Service Bulletin

Bulletin No.: 16-NA-198

Subject: Holes/Tears in Fabric of Sunroof Air Deflector

Brand:	Model:	Model Year:		VIN:		Engine:	Transmission:
		from	to	from	to		
Cadillac	CT6	2016	2016	SOP 2016	Prior to 1G6KK-5R66GU1-51485	All	All

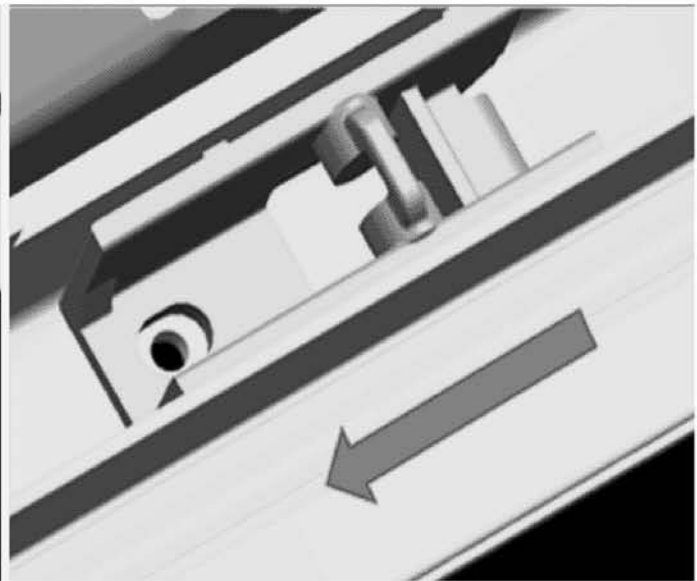
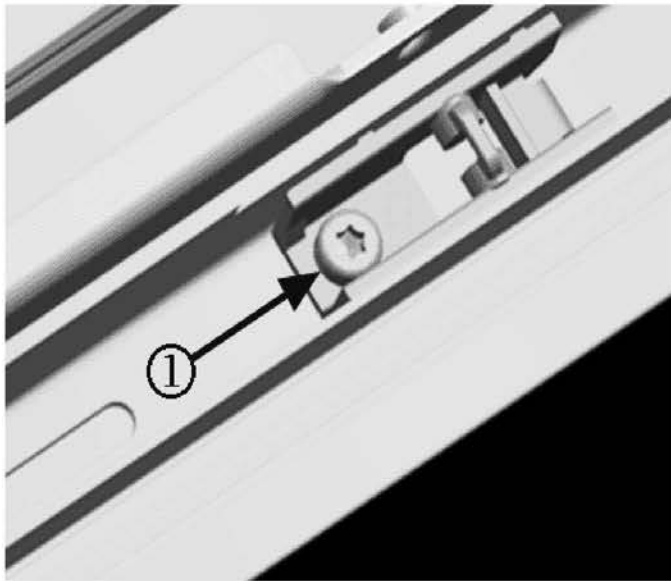
Involved Region or Country	NORTH AMERICA, JAPAN, KOREA, RUSSIAN FEDERATION, MIDDLE EAST, EUROPE, ISRAEL
Additional Options (RPO)	Equipped with Sunroof (RPO C3U)
Condition	 <p style="text-align: right; font-size: small;">4533530</p> <p>Some customers may comment on seeing tears (1) or a large hole in the sunroof air deflector fabric.</p>
Cause	The cause of the condition may be an interference where the air deflector is contacting the sunroof housing front beam and guide rails.

Replace the sunroof air deflector and reposition the deflector pivot brackets following the Service Procedure below.
